Docket Item #'s 14 & 15  
BAR CASE # 2005-0200  
BAR CASE #2005-0201

BAR Meeting  
October 5, 2005

**ISSUE:** Exterior Alterations & a Waiver of Rooftop HVAC Screening  
**APPLICANT:** Jane Slatter  
**LOCATION:** 811 Prince Street  
**ZONE:** RM/Residential

**Figure 2** Proposed south elevation

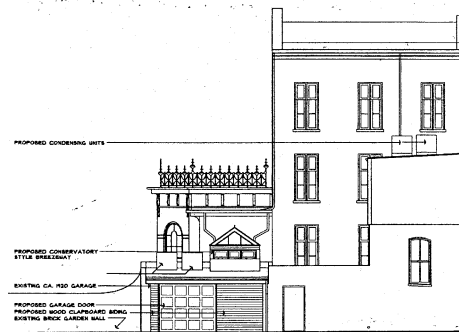
The only area which might be rethought is the short section of new masonry wall abutting the wood porch; in the absence of large scale details, this junction is a concern. The thought here is that a more appropriate response might be to consider the use of an open iron railing similar to that used on the new gate and entry stoop from the garden.
